Landing Gear Update!

Due to a design change to the production landing gear, some A-7 kits may require a minor modification to install the landing gear into the aircraft.

MAIN GEAR

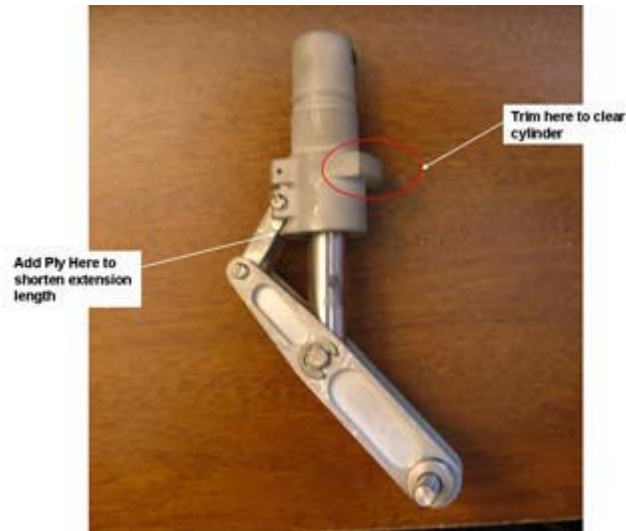
To install the main gear into these aircraft, the 4 mounting holes in the main gear landing plate must be slotted 1/32" inward toward the center of the plate. The retract should be centered on the plywood plate. In most cases, slotting the holes will work, while in other cases, completely creating new holes will be required. For easiest results, use a Dremel tool with a 3/32" cutter bit. It is ok if the holes are oversized as you want to ensure that there is no binding in the retract mechanism. Improper alignment can cause this.
